MEMORANDUM

RE: Wells St Assisted Living AZ, PPH-2021-0024

STAFF REPORT

SUBJECT: H-2021-0024
Wells Assisted Living and Andorra Subdivision

D. Open Space Exhibit (date: ~~5/7/2021~~ **July 13, 2021**)

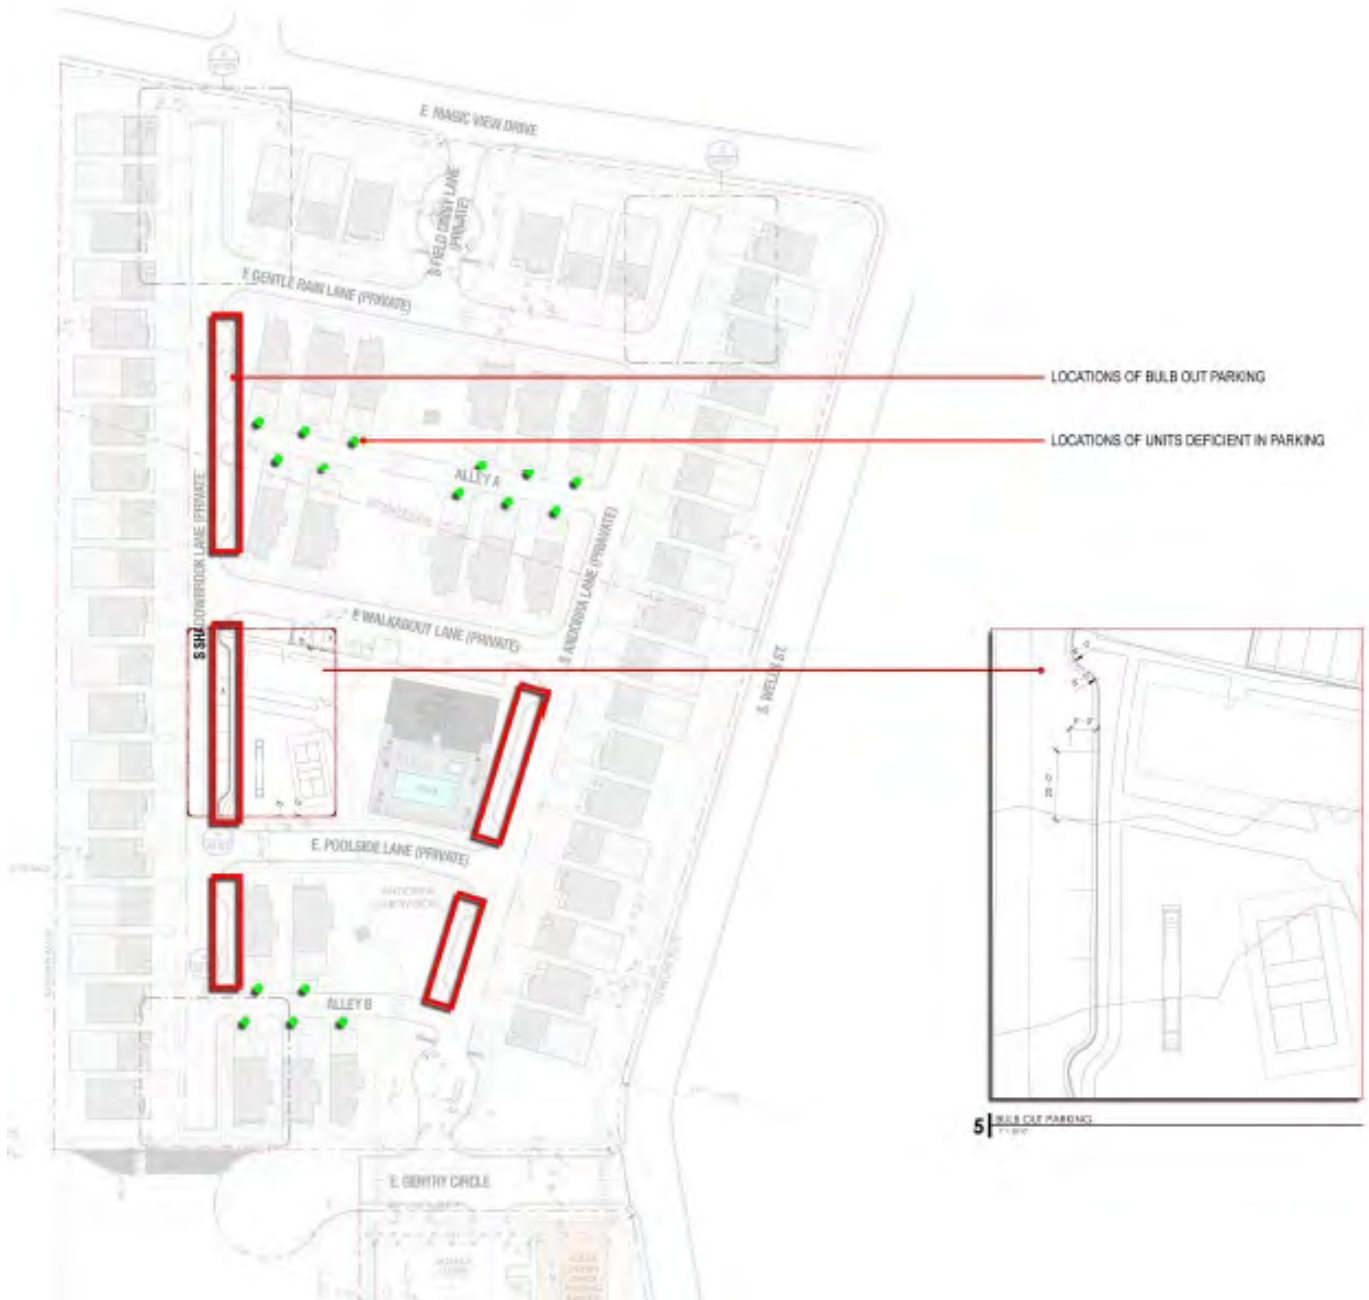
All residential developments over 5 acres in area are required to provide at least 10% of qualified open space. The applicant has submitted an open space exhibit. Based on an acreage of 11.79 acres, 1.18 acres of open space is required, whereas 21.5% is provided. All qualified open space meets the minimum dimensional requirements and appears to be landscaped as required per UDC 11-3G-3-E.

The applicant has provided revised plans. The plans increase the setbacks of all homes along the west property line to a minimum setback of 17'. The access to E. Magic View Dr. has been removed and retained for pedestrian and emergency access only and another access has been provided to S. Wells St. Lots have been extended in length so that all properties have 2 car garages and 2 car driveways. There are 21 additional guest parking spaces and 9 parking spaces have been provided for the clubhouse. This has resulted in a reduction in qualified open space from 21.5% to 20.6%.
